## Product Change Notice (PCN)

PCN Number: PCN-0451209R-01

Product(s) Affected: PJ-058BH

**NEW CUI DEVICES DETAIL / IMAGI**

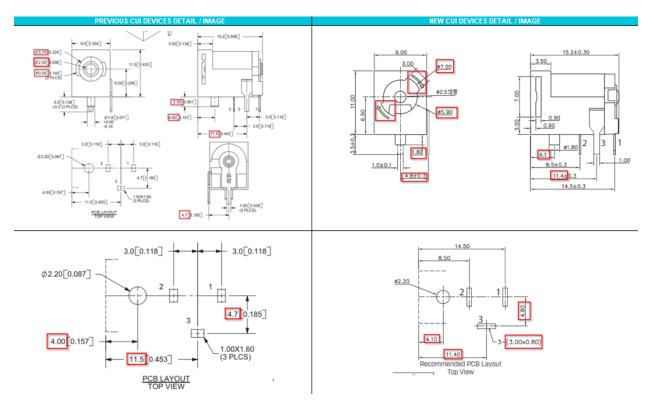
Description of Change: Minor Housing and footprint differences. Material Change on the housing and terminals. See image Below
